**APPLICATION AS NOTIFIED**

**(RM210657)**

### **SERVICE OF NOTICE / LIMITED NOTIFICATION**

**RM210657 – REQUEST FOR FURTHER INFORMATION RESPONSE**

ELEVATIONS. 1:100.

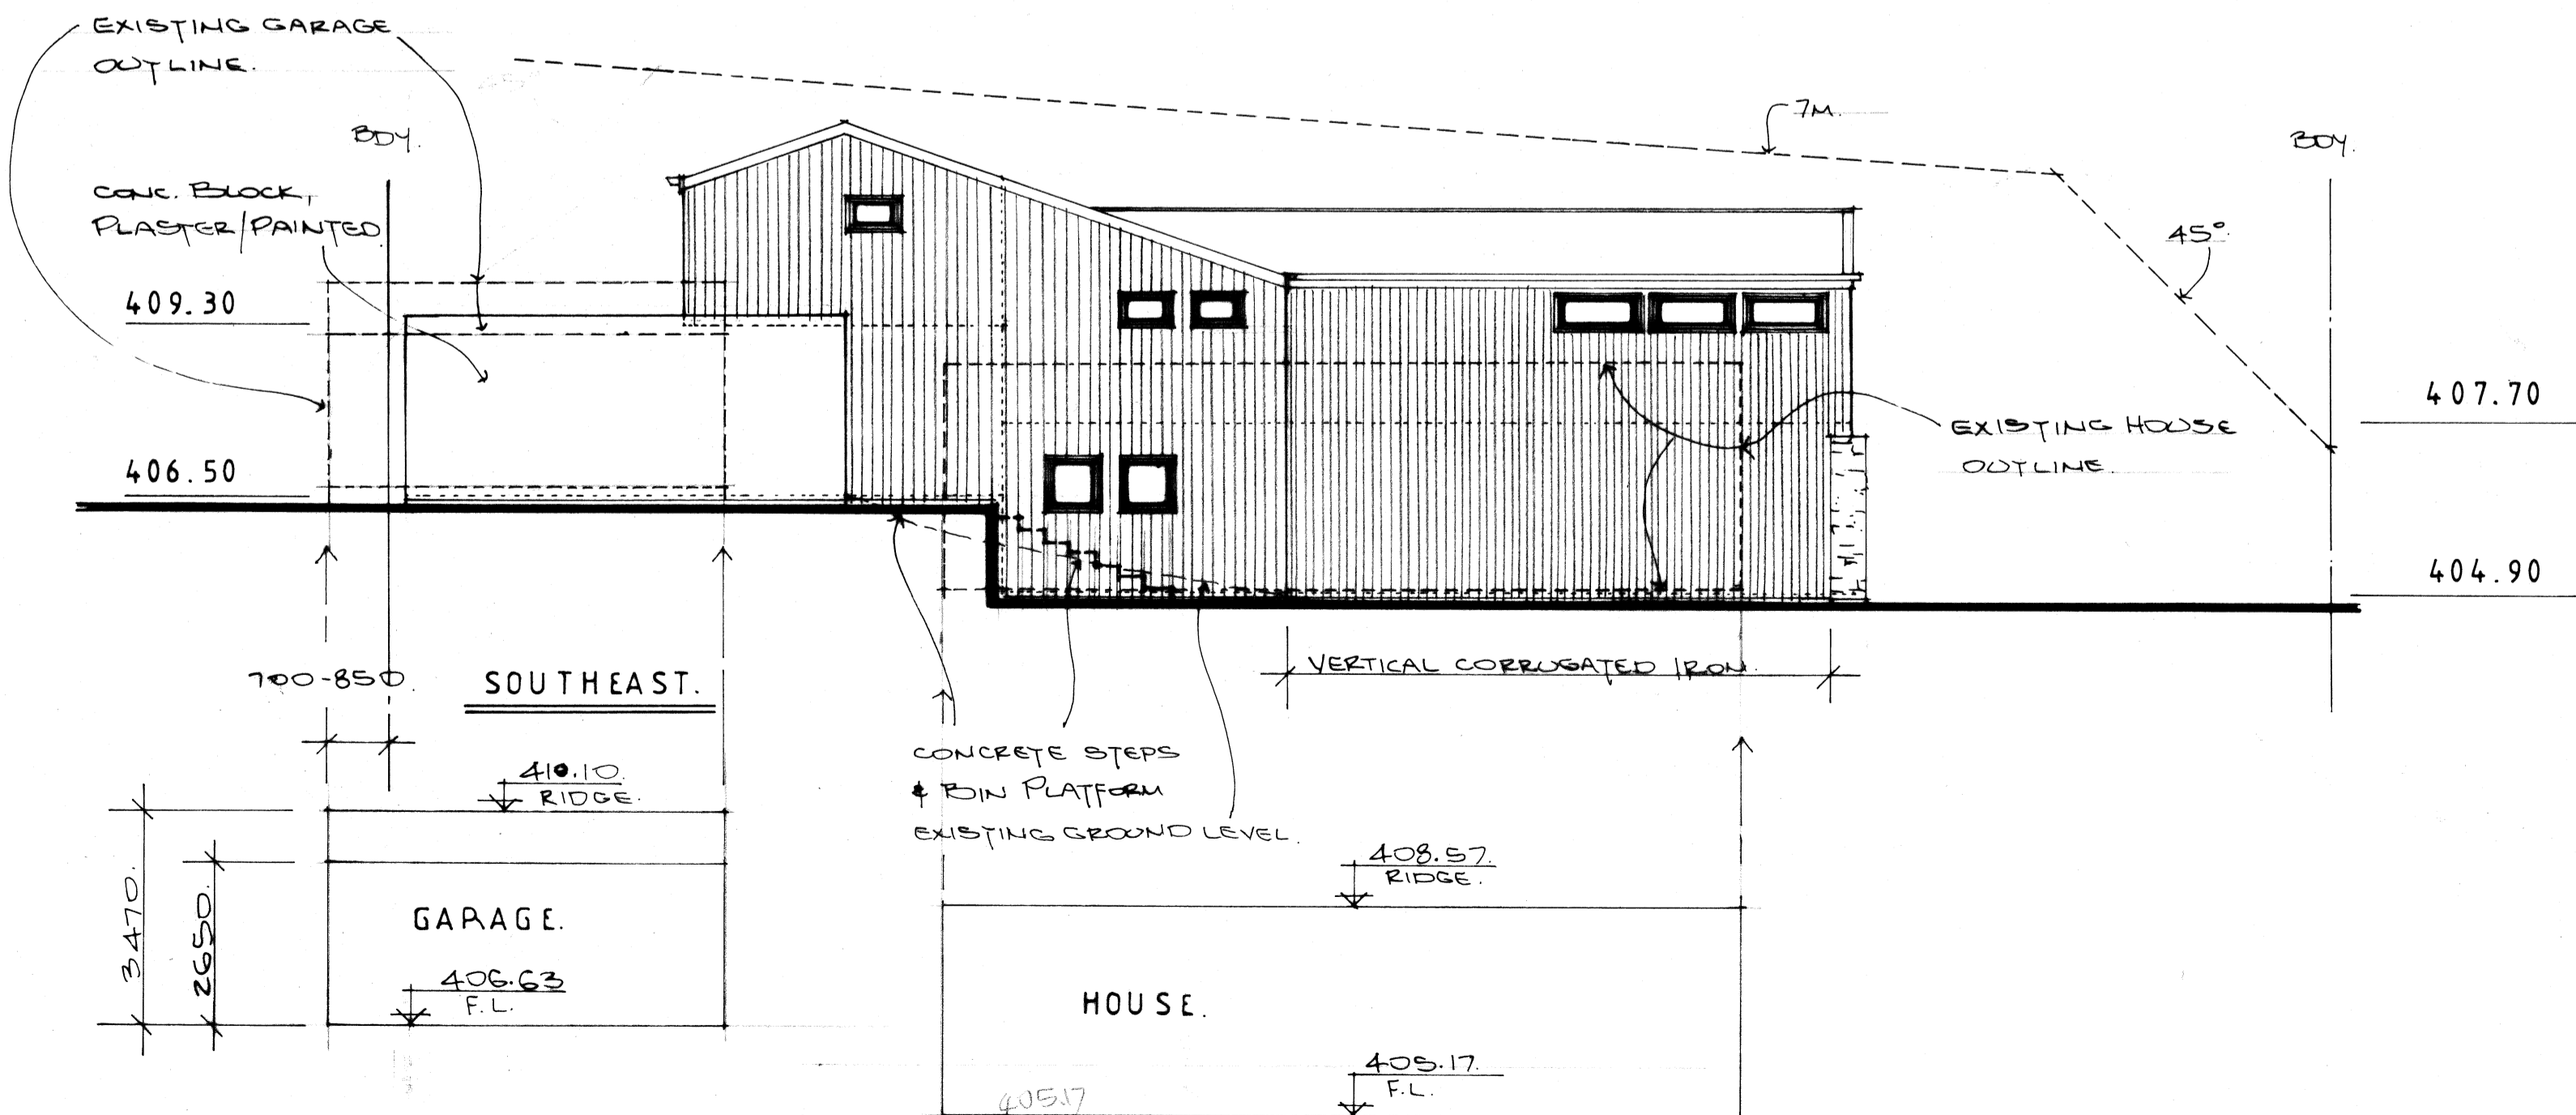
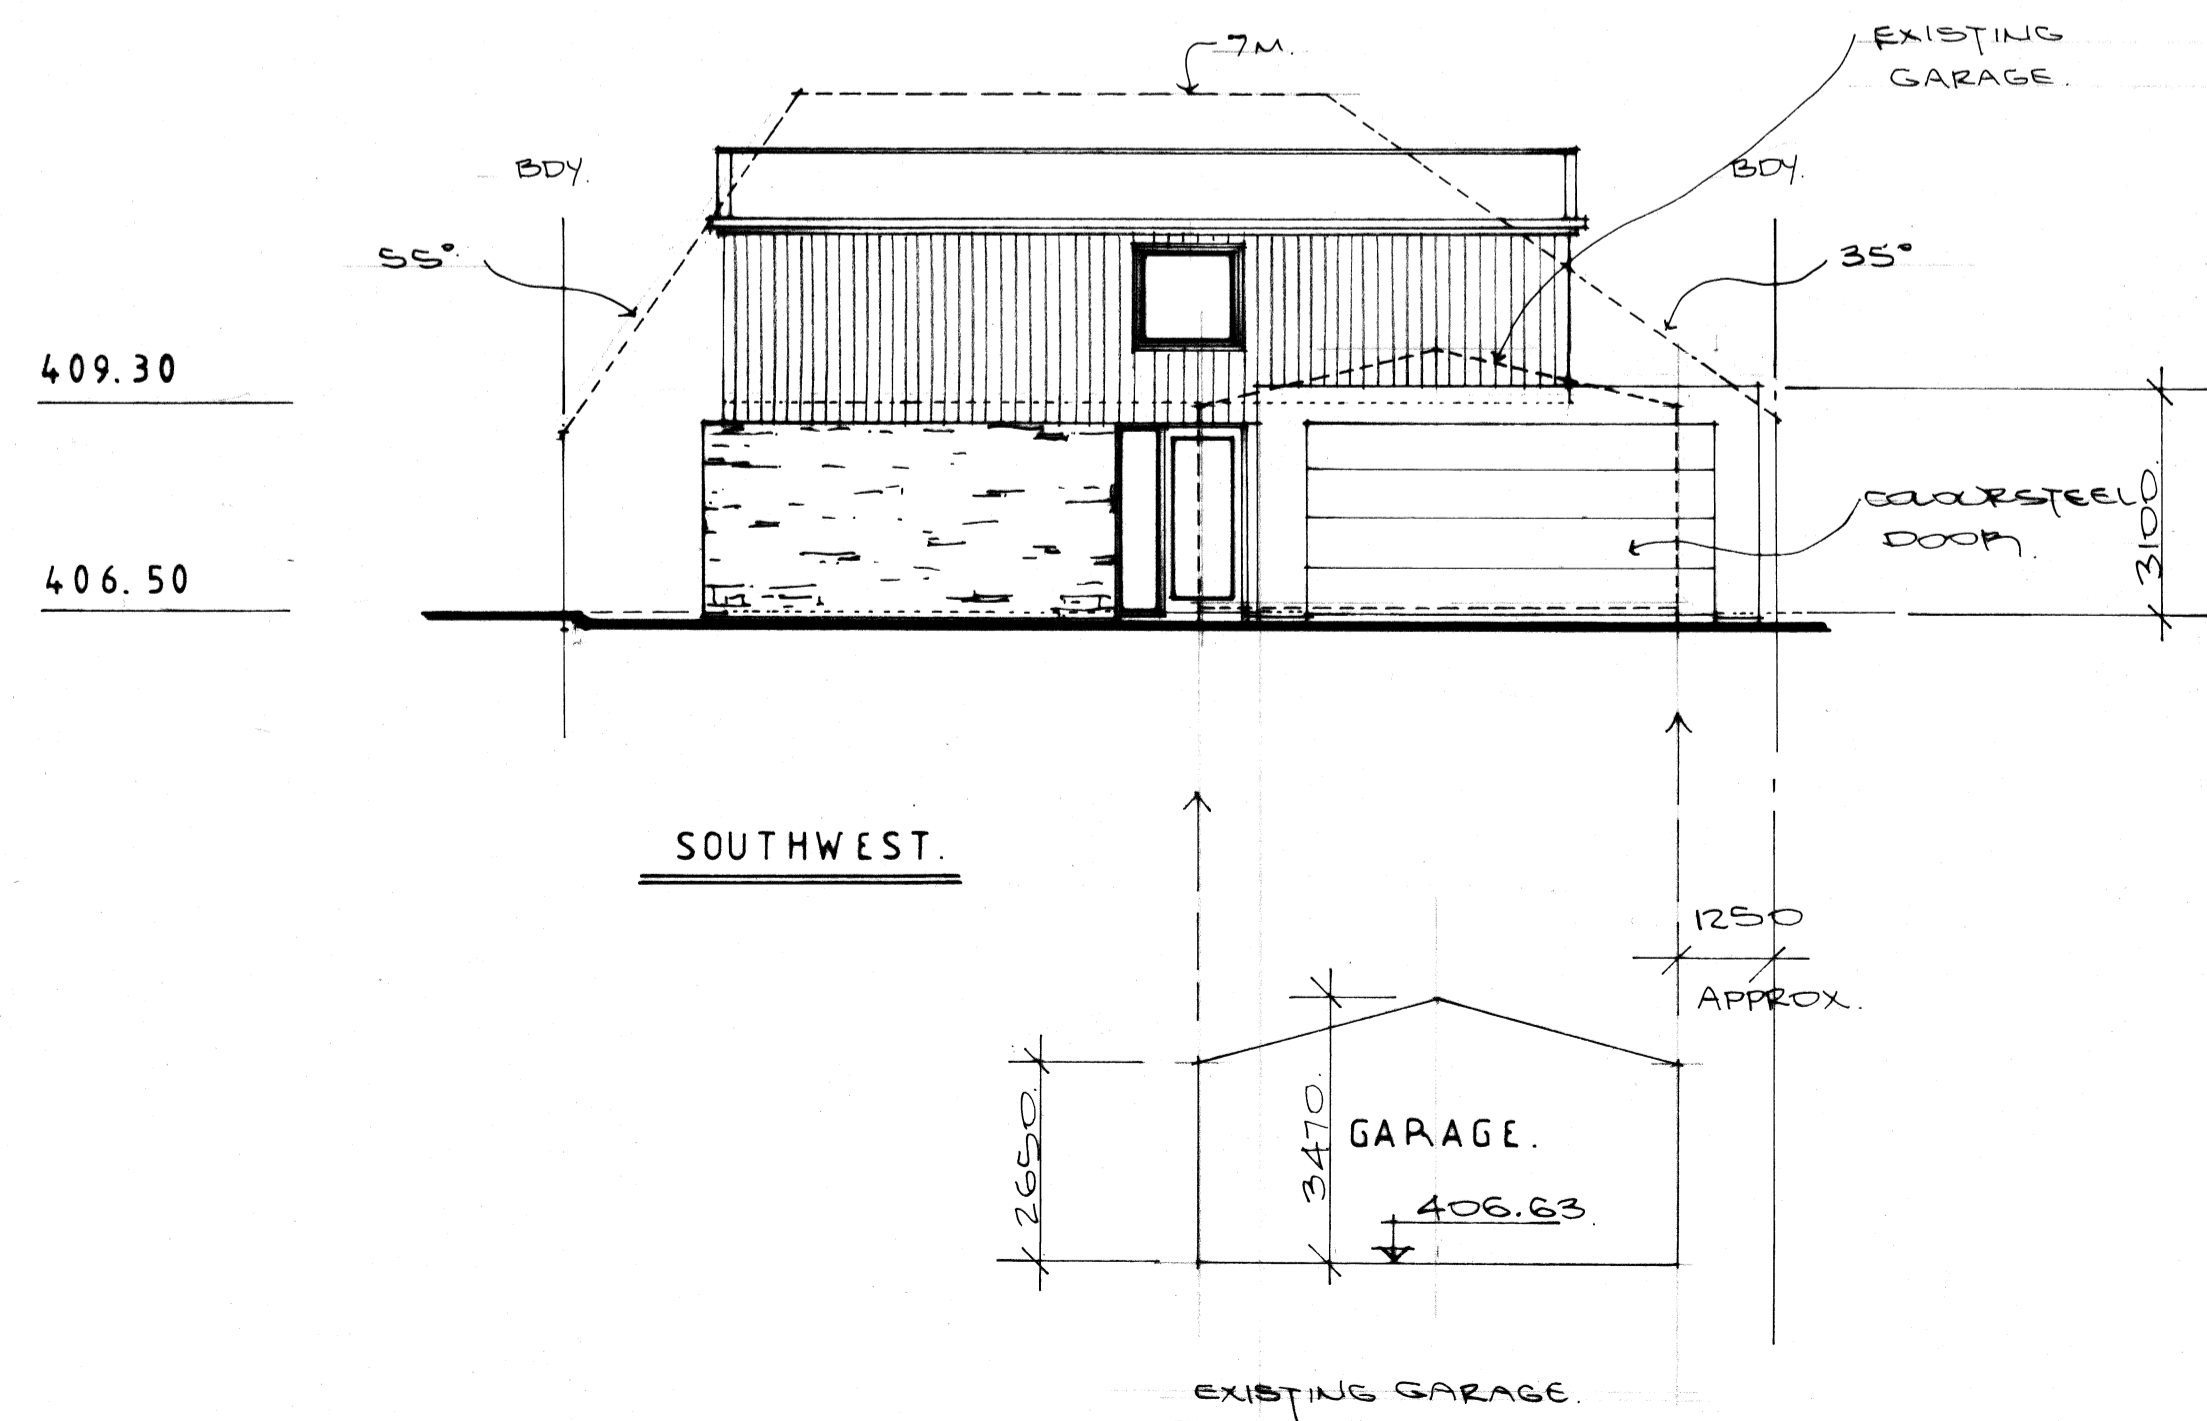
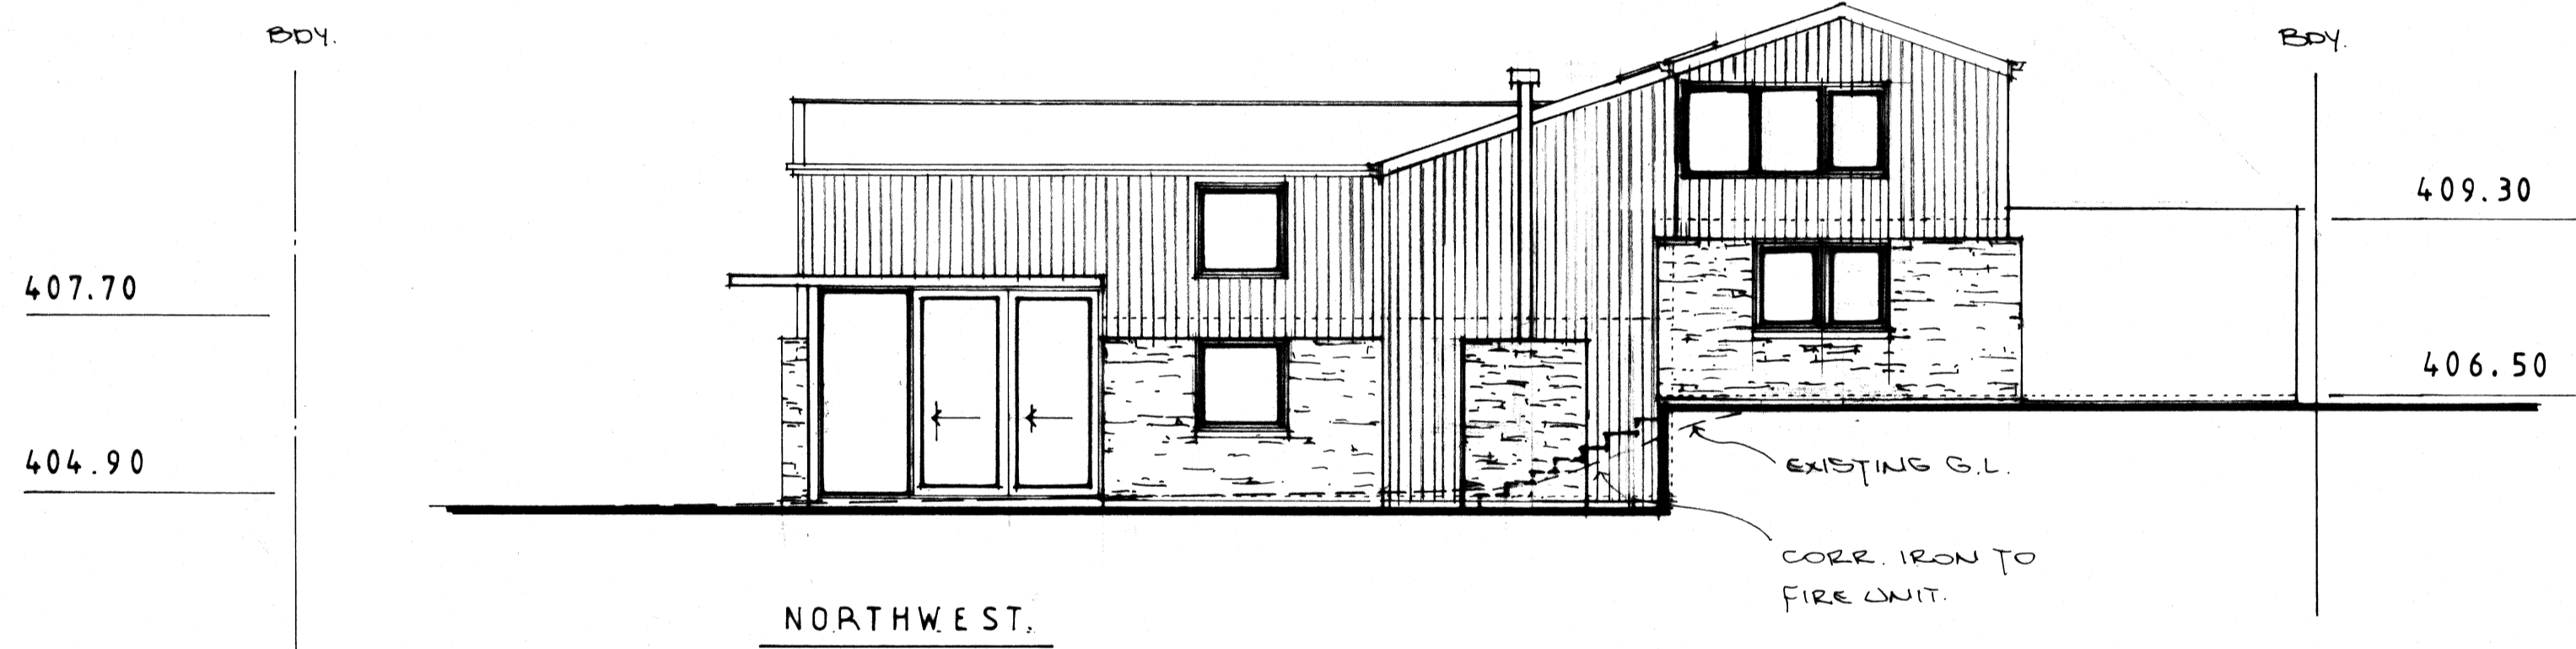
- 5. The AEE states that the garage door will be constructed out of timber boarding stained dark brown but the elevations state it will be Colorsteel. Please confirm which is right and correct the relevant document.*
